INDIANA DEPARTMENT OF ENVIRONMENTAL MANAGEMENT

Re: NPDES Permit No. IN0000205
ArcelorMittal Indiana Harbor, LLC – Indiana Harbor West
East Chicago, Indiana
Lake County

A response to the comments received pertaining to the draft NPDES permit is contained in the Post Public Notice Addendum. The Post Public Notice Addendum is located at the end of the Fact Sheet.

INDEX
for
ArcelorMittal Indiana Harbor West NPDES Permit IN0000205

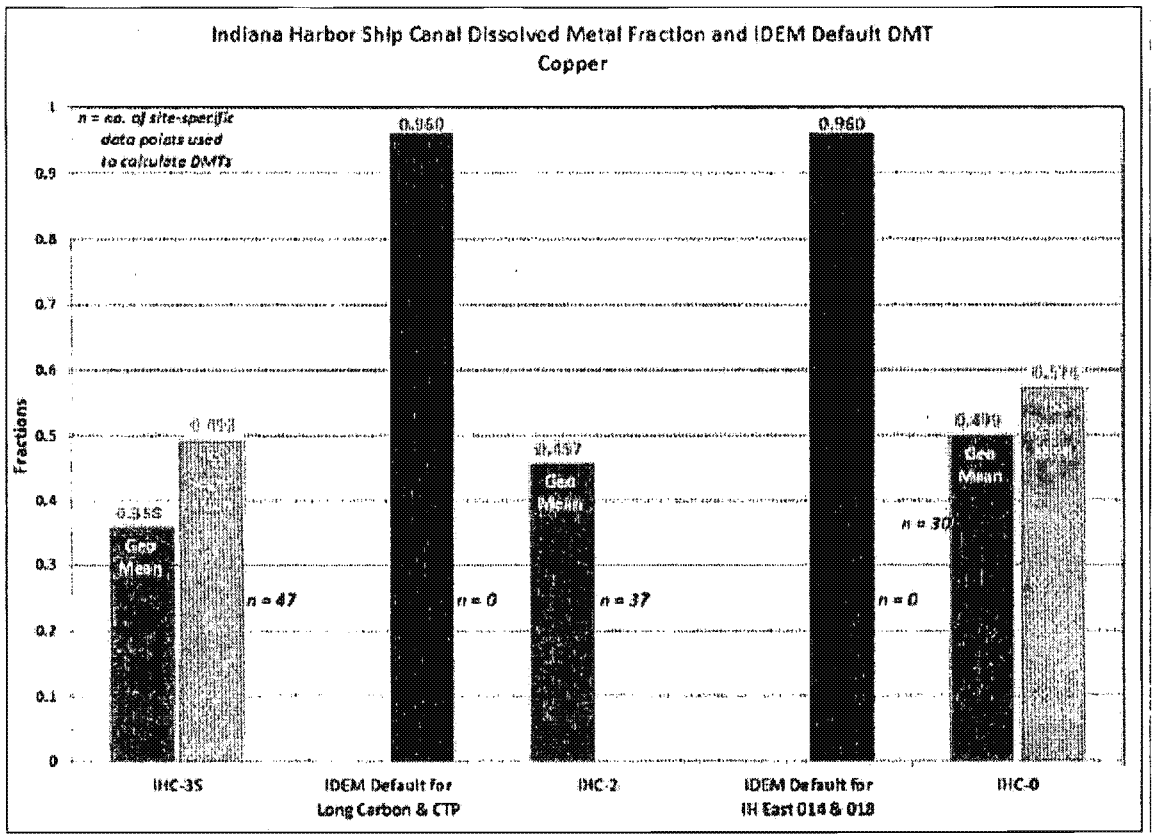
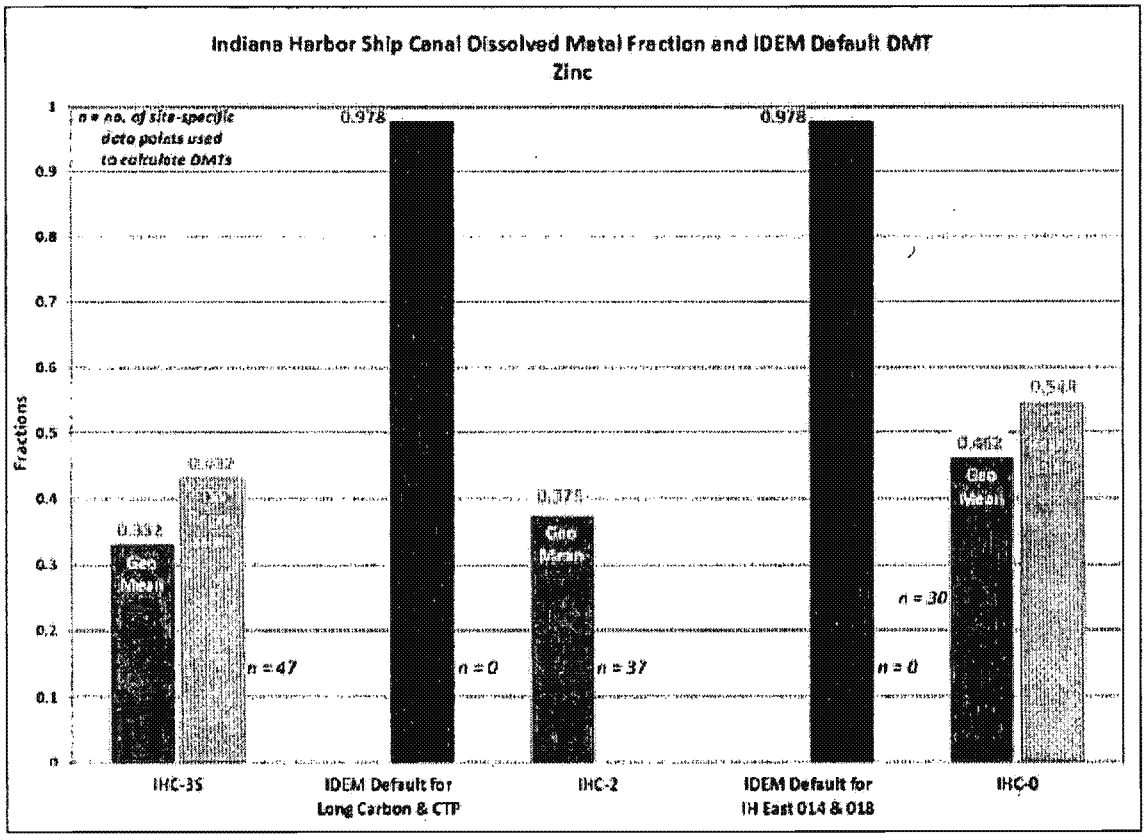
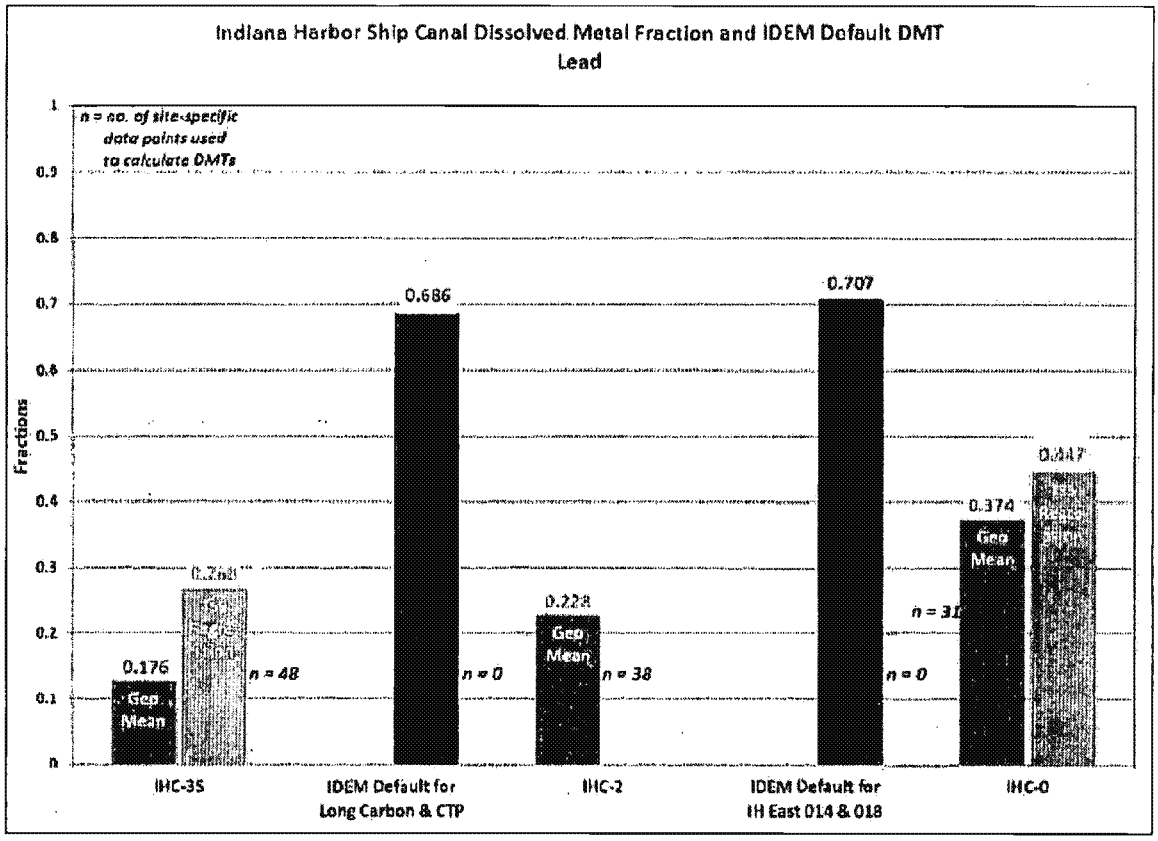
IDEM's default DMTs, which rely on no data specific to the IHSC, are clearly inaccurate for the ArcelorMittal permits and overestimate the dissolved copper, lead and zinc fractions in the IHSC by significant amounts. For example, the default translators are 2.1, 3.0 and 2.6 times greater than the calculated geometric mean of the dissolved fractions for copper, lead and zinc, respectively, at IHC-2. Even the 95th percentiles of the dissolved fractions for all metals at all locations are significantly below IDEM's default translators. As shown, the DMTs calculated at IHC-3S, IHC-2 and IHC-0 are considerably lower than IDEM's default DMTs used in the calculation of WQBELs. Graphs of the geometric mean dissolved fractions, TSS-regression developed DMTs, and IDEMs default DMTs are presented below.

Given the data presented in the table and graphs above, it is not reasonable to assume, as IDEM has done through use of the default DMTs, that the dissolved metal fraction in the water column somehow increases dramatically in between the fixed monitoring stations. ArcelorMittal's requested effluent limits, based upon site-specific DMTs derived from the IDEM fixed monitoring station data and other factors, are presented below.

ArcelorMittal Indiana Harbor West
Instream Temperature Monitoring Study
Maximum Instream Temperature vs. Indiana Water Quality Standard
April to November 1998

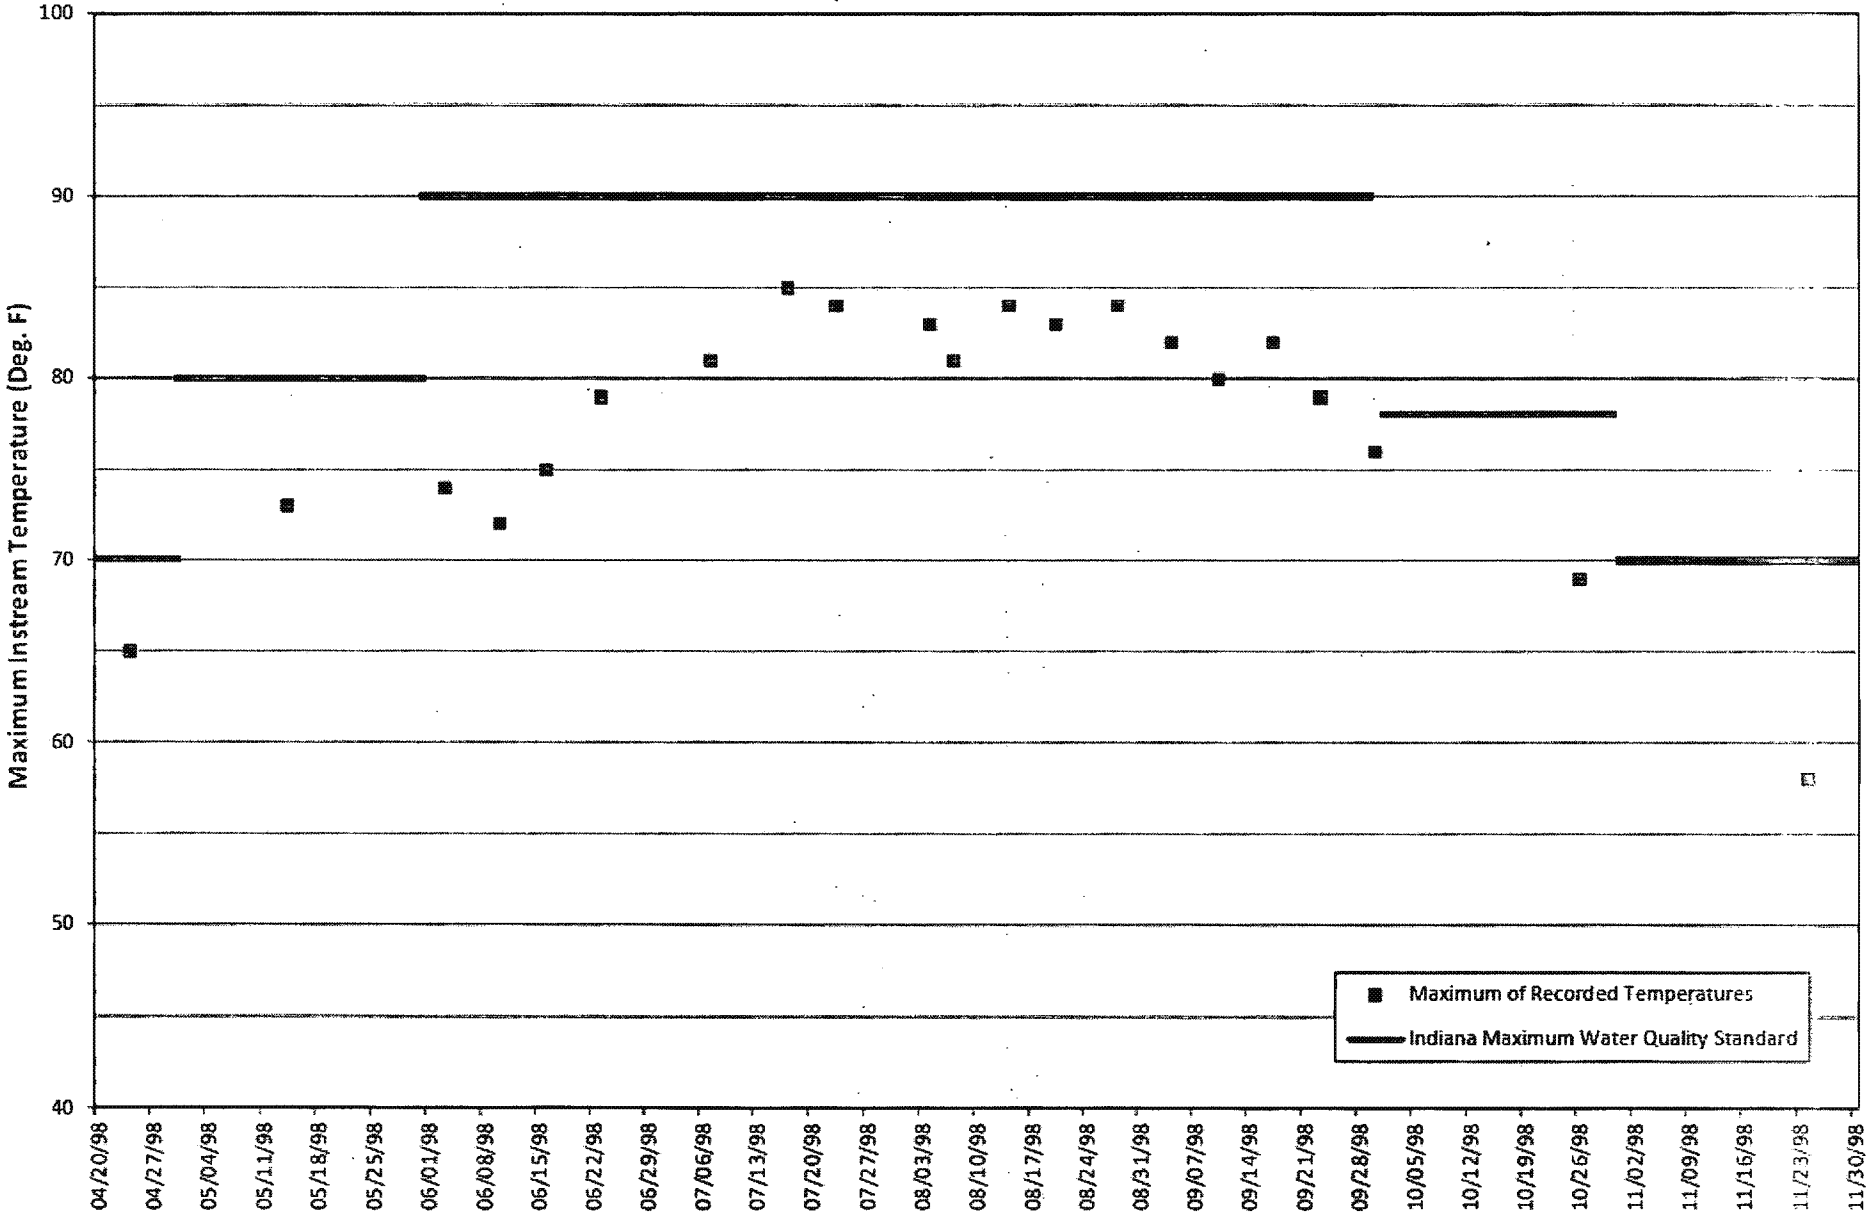
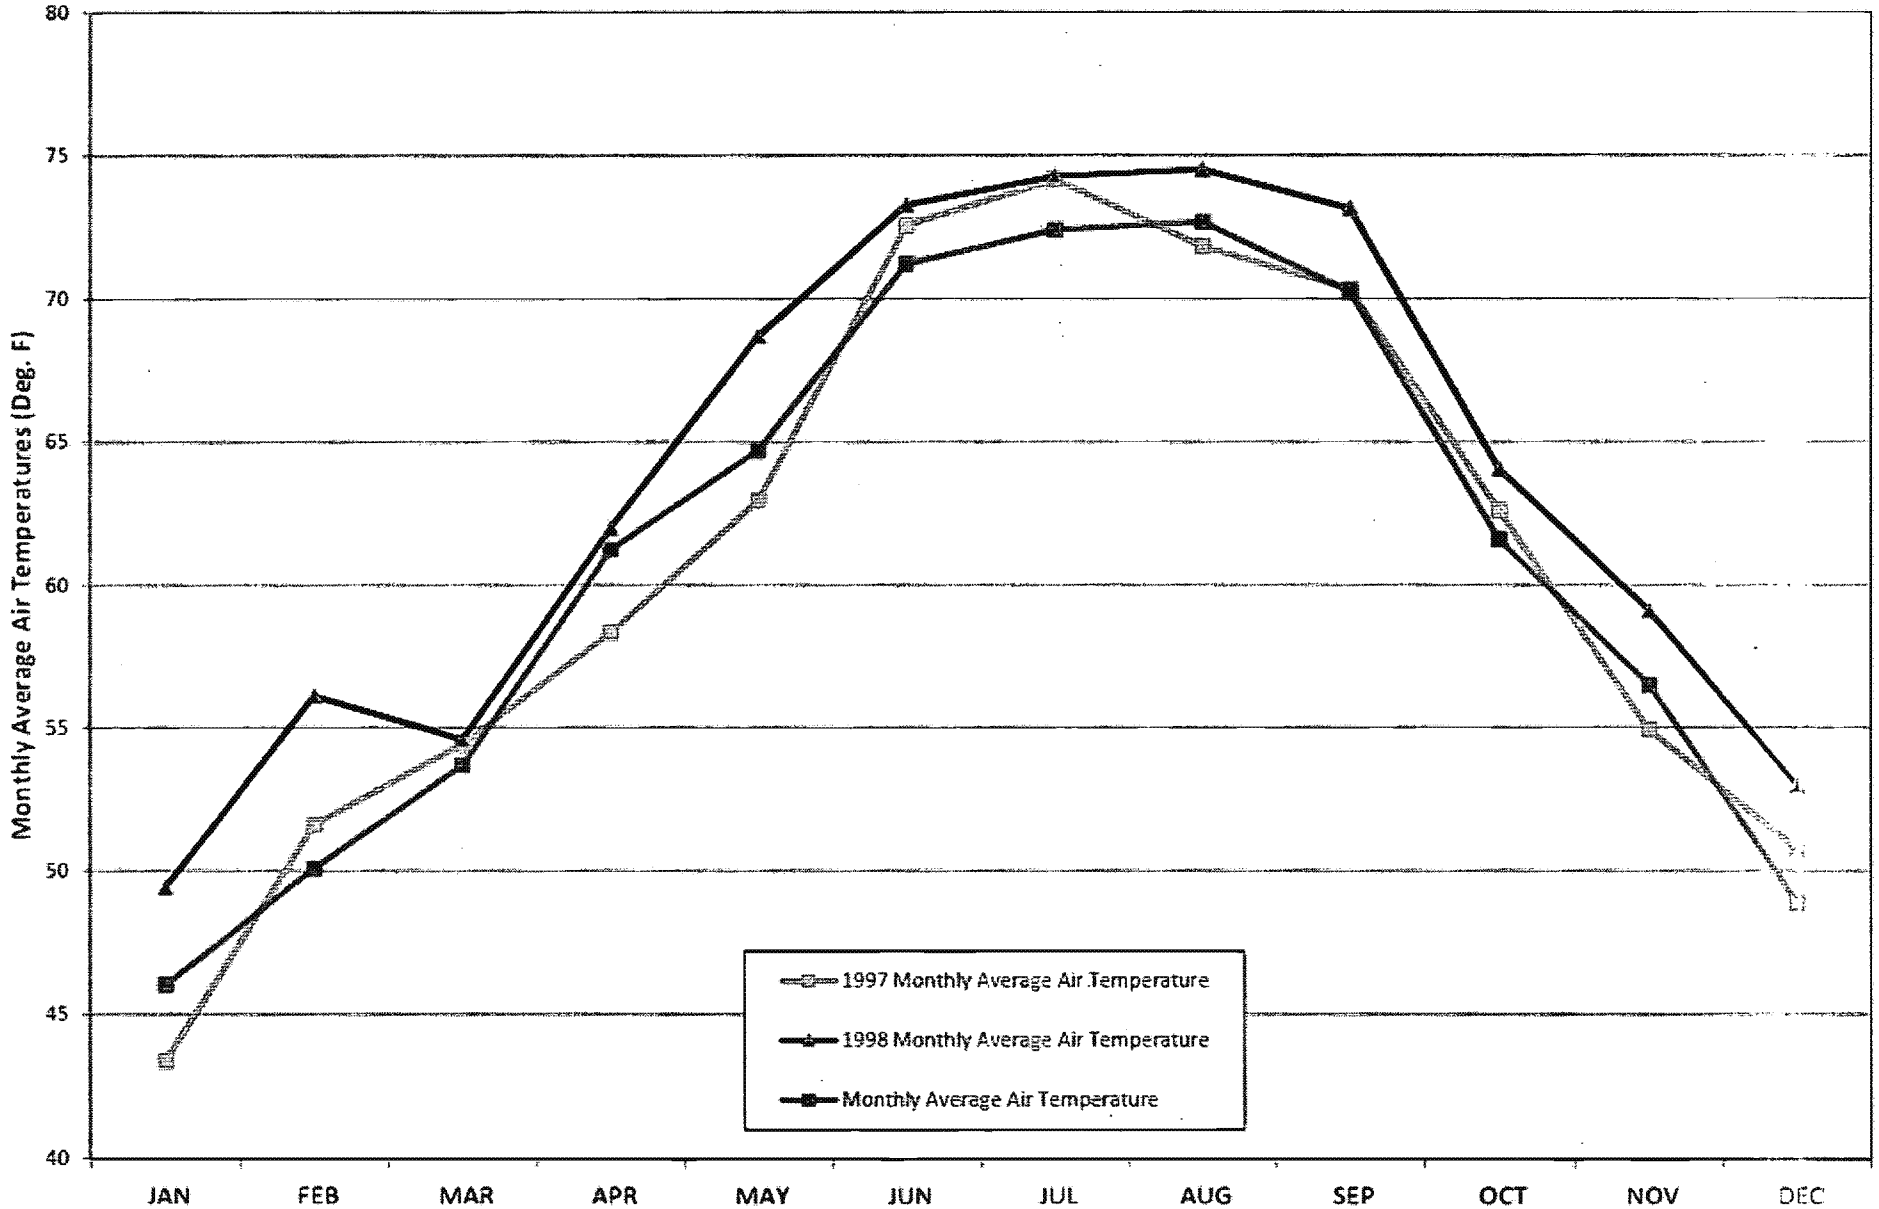
The in-stream temperature monitoring data show maximum temperature water quality standards were met at all locations monitored in 1997 and 1998. The results are shown graphically in Figures 1 and 2.

These data show ambient air temperatures in 1997 and 1998 were typical of historic conditions and suggest in-stream temperatures for 1997 and 1998 are representative of thermal discharges at the time and typical summer air temperatures. Monthly average data for January through December are included as Exhibit C and are shown graphically in Figure 3.

FIGURE IHW-1

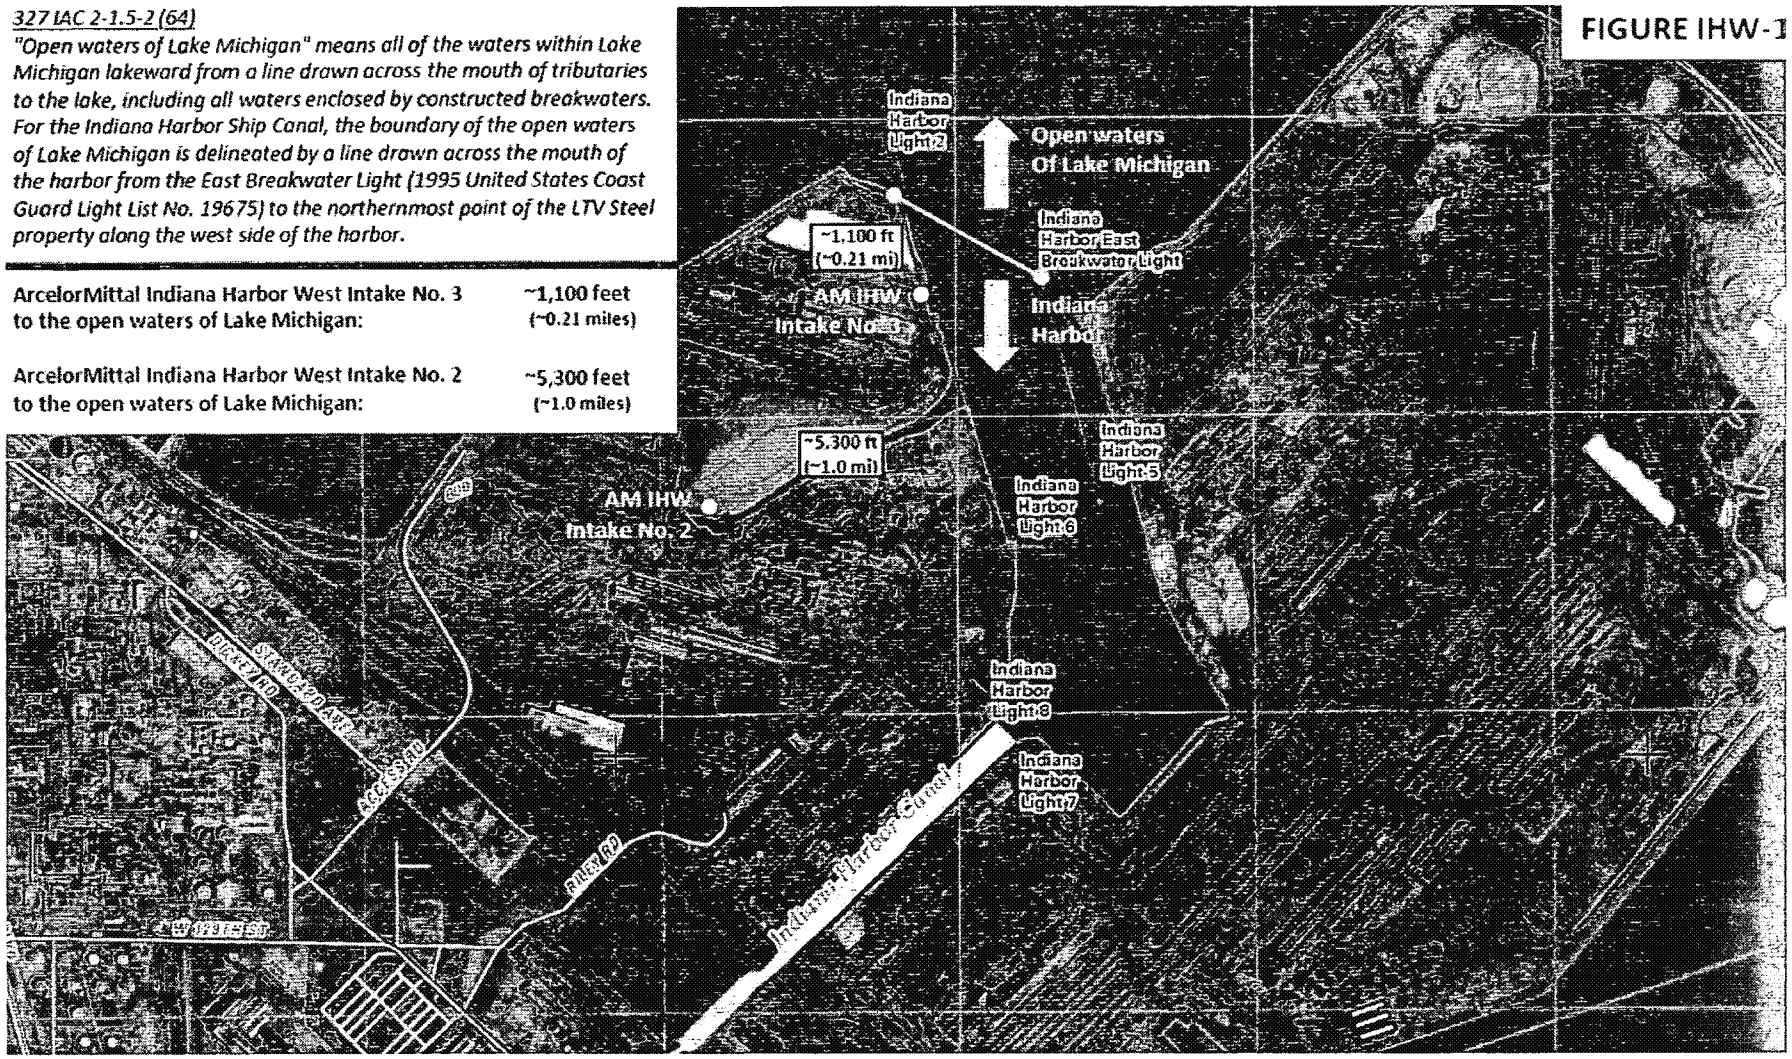
IDEM states in Attachment A of the Fact Sheet (p. 5), that Indiana Harbor West has two water intakes in Lake Michigan; and, that IDEM considers the intake channel for the Nos. 2 and 3 intakes as "open waters of Lake Michigan" (p. 12). Figure IHW-1 is an aerial photograph showing the Nos. 2 and 3 intakes, the intake channel and the northern section of the Indiana Harbor Ship canal that borders the open waters of Lake Michigan. A line depicting the boundary described in the above definition of "open waters of Lake Michigan" is shown on the aerial photograph. It is evident from a simple reading of the regulatory definition of "open waters of Lake Michigan" and review of the aerial photograph that the Indiana Harbor West intake channel and the Nos. 2 and 3 intakes are not within open waters of Lake Michigan. They are not lakeward of the line between the East Breakwater Light and the northernmost point of LTV Steel property (now ArcelorMittal Indiana Harbor LLC property). In fact, the No. 3 Intake is approximately 0.21 miles south of the northernmost point of ArcelorMittal property and the No. 2 intake is approximately 1.0 miles south and southwest of the northernmost point of ArcelorMittal property. Thus, IDEM's assertion that the intake channel for the Nos. 2 and 3 intakes are within the open waters of Lake Michigan is wrong, and any applications of Indiana water quality
